HISTORIC PRESERVATION COMMISSION

Hearing: December 8, 2011 Staff Report

HPC11-00737

106 W Church St

All Saints' Church - existing walkway from Church Street to Office Building, Memorial Garden & Coloumbarium. area between retaining wall and steps is to narrow for wheelchair.

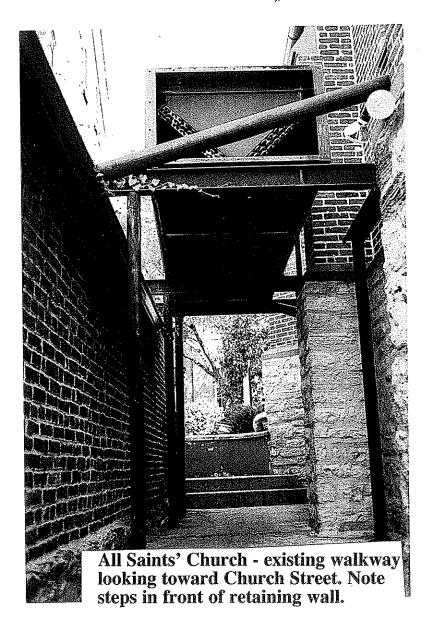
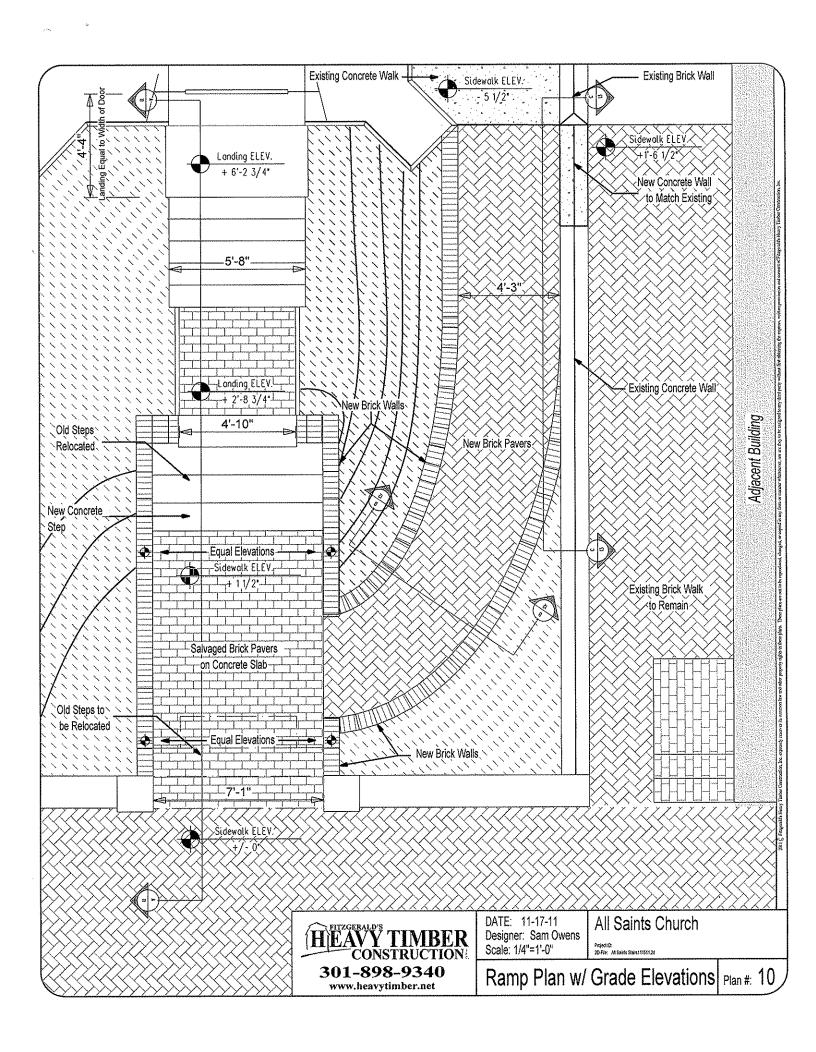
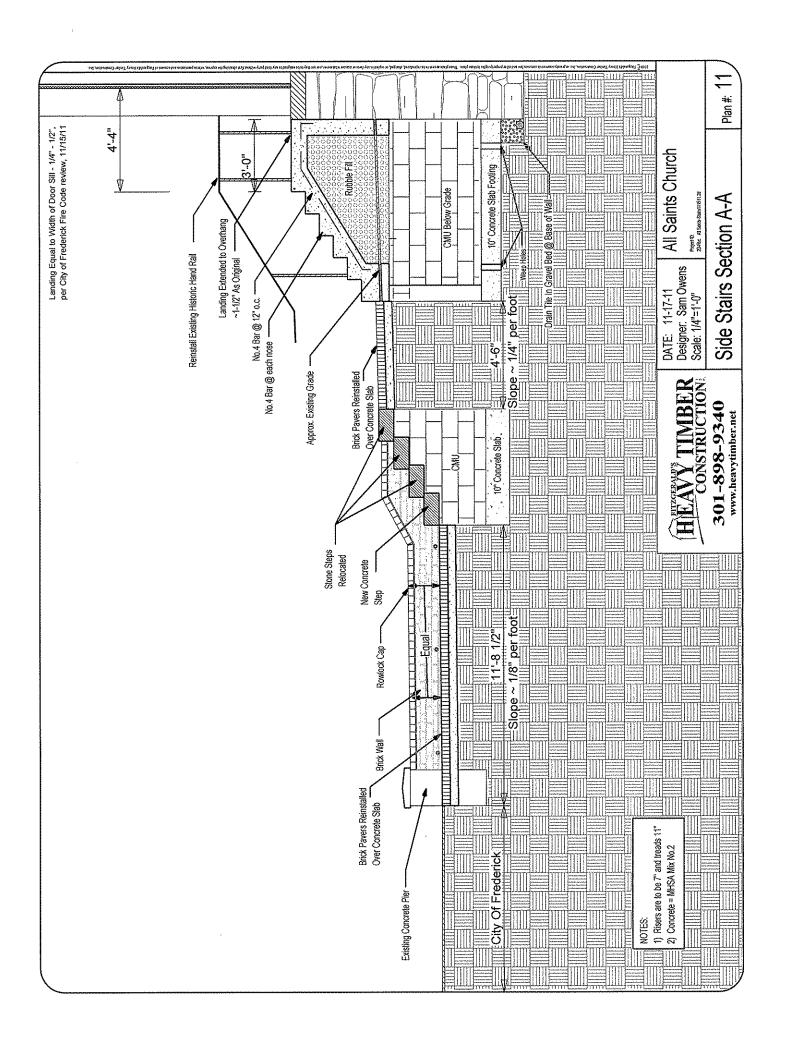
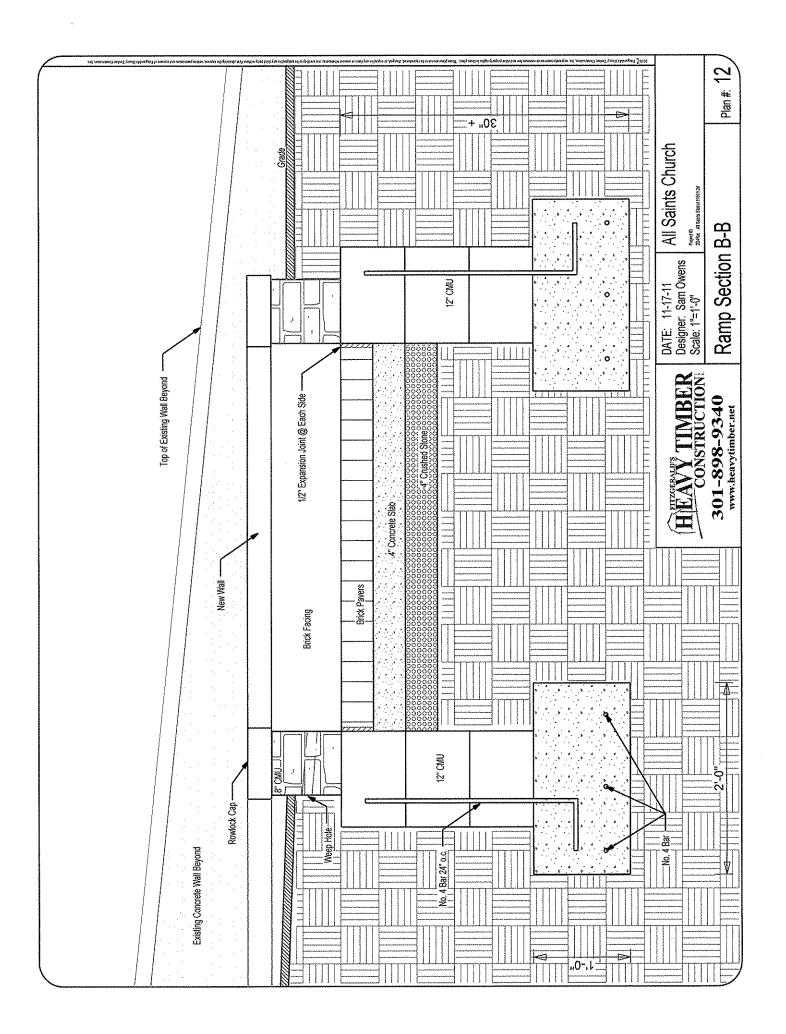
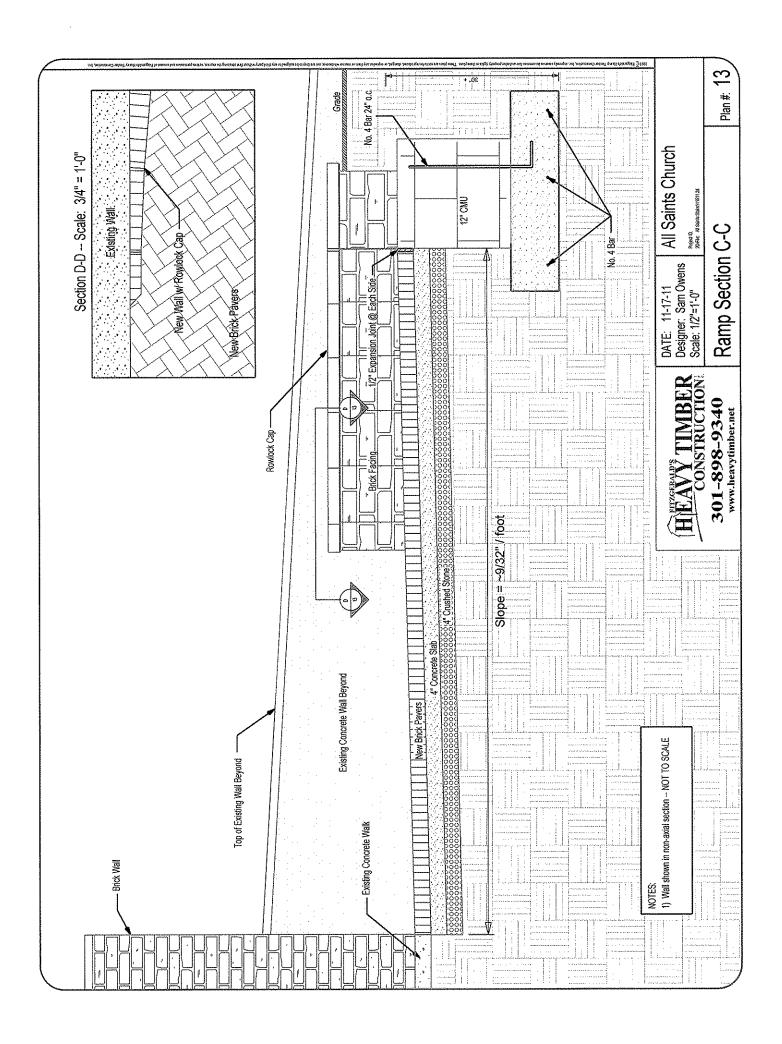
The construction date of the walkway is unknown; however the brownstone steps are a historic and significant element. The Frederick Town Historic District Design Guidelines state that "Historic landscape features must be identified, repaired, and preserved" (pg. 120). Staff finds that relocating the brownstone steps will preserve the historic material while accommodating the construction of an ADA compliant ramp. Staff also supports the reuse of the original brick and suggests that the herringbone brick pattern is used rather than a running bond.

Staff finds that more detail should be provided to show how the original wrought iron railing will be reinstalled. The height of the railing will most likely need to be readjusted and will also need to be modified to allow access to the new ramp.

The proposed ADA compliant ramp will be approximately 4'3" wide and will feature brick set in a herringbone pattern. The walkway will be flanked by brick walls. To accommodate changes in the grade the west wall will be approximately 12" in height and the east wall will be as high as 3 feet. The following alterations are proposed to construct the ramp:

It is likely that the landscaping located in the northwest corner of the property, which currently obscures a city-owned spotlight, will be damaged during construction. *The Design Guidelines* state that "The Commission may require HVAC equipment and other utilities to be screened from view from the public way. Screens approved by the Commission may be fencing, plant materials, or a combination...If plant materials are required for screening; shrubs must be at least two feet high when planted... Evergreen species must be planted if the conditions would foster healthy growth of evergreen species" (pg. 121). Staff finds that this landscaping element should be preserved if possible or replaced with a suitable evergreen plant if necessary.

That the original brick of the existing walkway is relayed in a herringbone pattern rather than a running bond;

- That the existing opening in the concrete retaining wall located at the west property line will be infilled with new concrete that matches the color, texture, and design of the rest of the wall; and
- That the landscaping located in the northwest corner should be retained if possible. If the shrubs cannot be preserved, then they are to be replaced with an evergreen species that must be at least two feet in high when planted.
